Stage Line

PA 3000

"Änderungsplan für PR-8000/6000/3000"

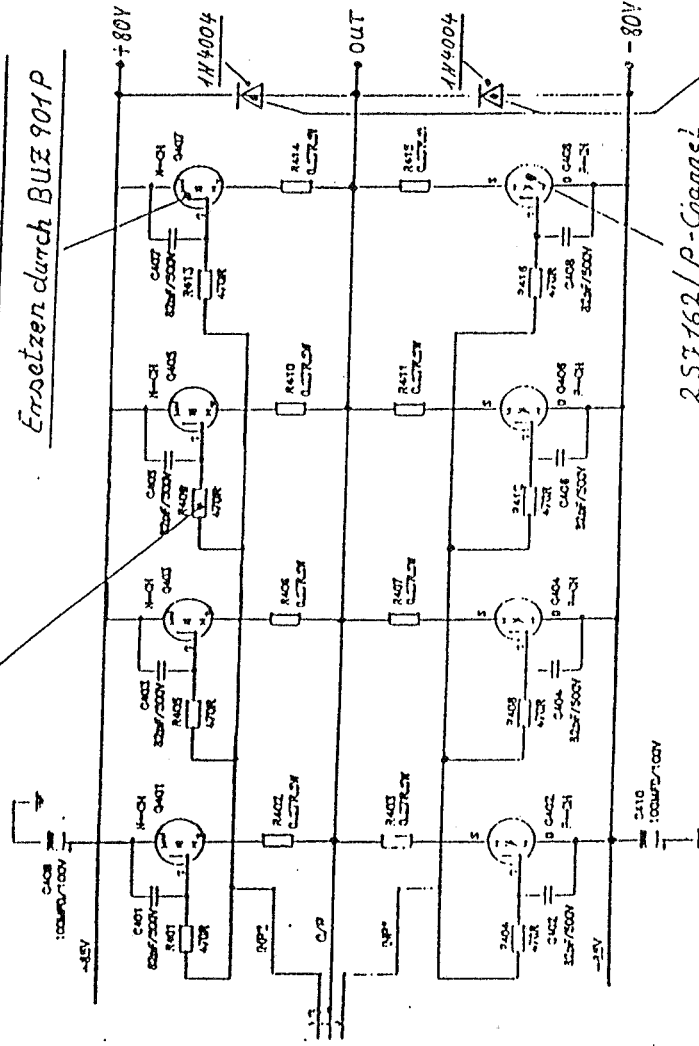
Tauschen der Endstufentransistoren.

Alle Gate-Vorwiderstände
nur bei BUZ 901P von
470 Ohm auf 1K Ohm erhöhen.

2SK1058 / N-Channel:

Ersetzen durch BUZ 901P

2SJ162 / P-Channel:

Ersetzen durch BUZ 905P

Zusätzlich 2 Dioden auf der
Endstufenplatine wie abgebildet
einbauen.
